April 8, 2019

I appreciate the opportunity to comment on the May 2018 modeling protocol for the USG Interiors facility (USG), located in Red Wing, MN. The list of comments below is focused on the modeling input and methodology sections of the protocol.

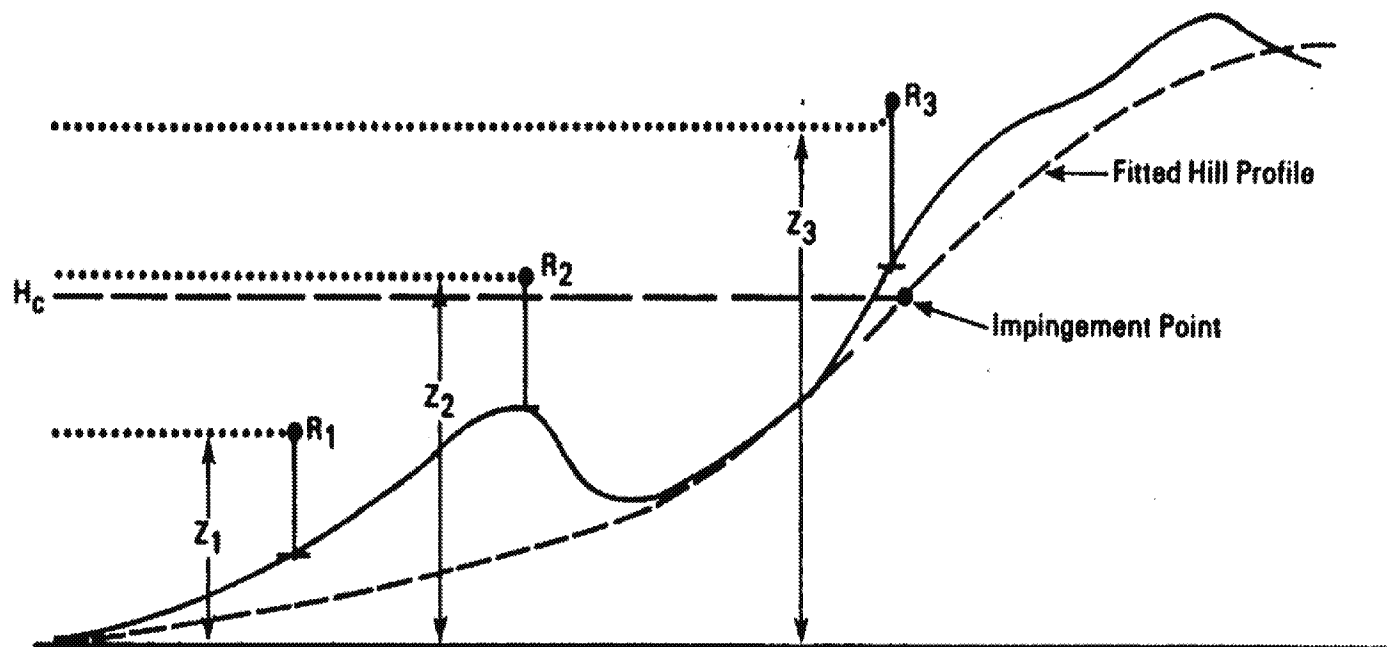
- 16) Section 6.2, Page 37: Given the potential importance of the bluff located just a few hundred meters due north of the facility (especially in the AERMOD modeling), should it be included in CTDMPPlus as a separate hill? My concern is that it's difficult to see how that hill feature is characterized and as part of the larger idealized Hill #1, the important bluff feature may get smoothed out. However, Figure 2-39 from the CTDMPPlus User's Guide seems to speak to this issue and perhaps it's addressed in the model but it's not clear to me.
